PLANNING NOISE IMPACT ASSESSMENT

“GILRIDGE”, BRIGHTON ROAD, HANDCROSS, RH17 6BZ

Our Ref: 7195_001R_3-0_WR.docx

8 RESPONSE TO COMMENTS PROVIDED BY ENVIRONMENTAL PROTECTION

Figure 7.1: First Floor GA plan showing proposed locations of plenum windows in bedrooms (red)

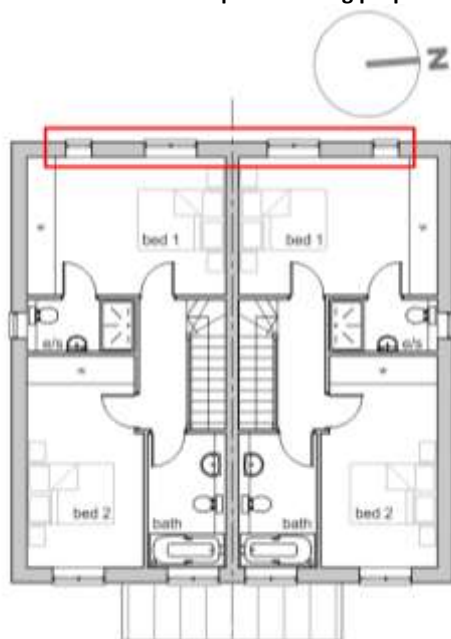
Accordingly, as it is not yet fully or clearly demonstrated that Good Acoustic Design has been followed, we request that either the design is amended, or that the Acoustic Design Statement is updated to justify the present configuration (specifically addressing the issues raised above) before we make further comment. Residential properties that require windows to be kept closed are sub-optimal and, in our view, should only be considered where it can be demonstrated that there is no alternative.

Further to discussions with Lightbox Architecture, it is proposed to install acoustic plenum windows to the west facing first floor bedrooms of Plots 3 and 4. When open, plenum windows can typically provide a sound reduction between 17-24 dB which should allow for acceptable internal noise levels within the first floor bedrooms of Plots 3 and 4. The proposed locations of these are shown in Figure 7.1, below

As per the above response, plenum windows have now been introduced to the first floor west-facing bedrooms of Plots 3 and 4.

Figure 7.2: Site plan markup showing proposed extent of 2.7m high acoustic barrier treatment on western site boundary

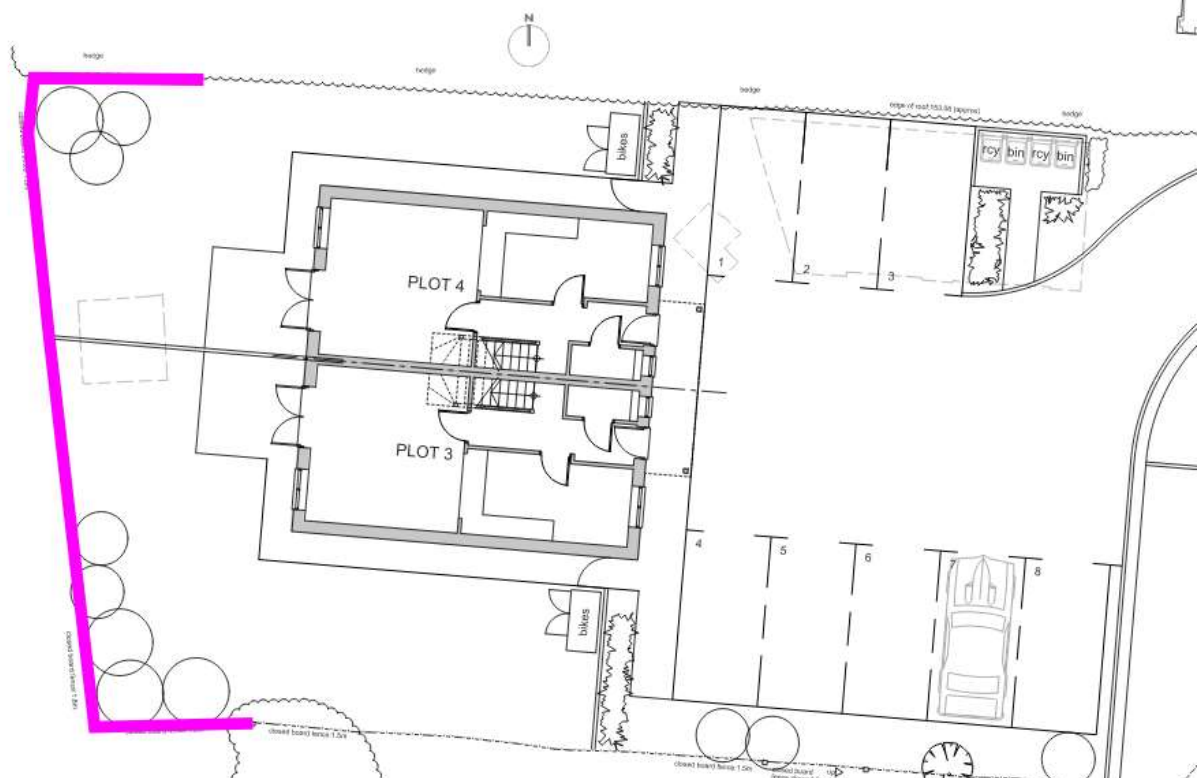
1. How much area of each private garden exceeds $L_{Aeq, 16\text{-hour}}$ 55 dB
2. Further evidence that Good Acoustics Design has been followed in the design, given the vicinity of the A23
3. Whether alternative natural means of cooling can be provided, e.g. plenum windows

A solid acoustic barrier is proposed along the western boundary of the site, which would provide additional acoustic screening to the rear gardens of Plots 3 and 4, as well as the wider development. The solid acoustic barrier to the west of site should have a minimum surface mass of 15 kg/m² and have a minimum height of 2.7m above ground level. The solid barrier should have very minimal perforations in the material and no gaps below or between the panels. Typical examples of suitable materials include a single layer of 24mm standard density plywood or 14mm cement particle board. The extent of the barrier should run along the full western site boundary and wrap around to the north and south boundaries as shown in Figure 7.2.

Figure 7.2 is a site plan markup which shows the proposed extent of the 2.7m acoustic barrier to the west of site.
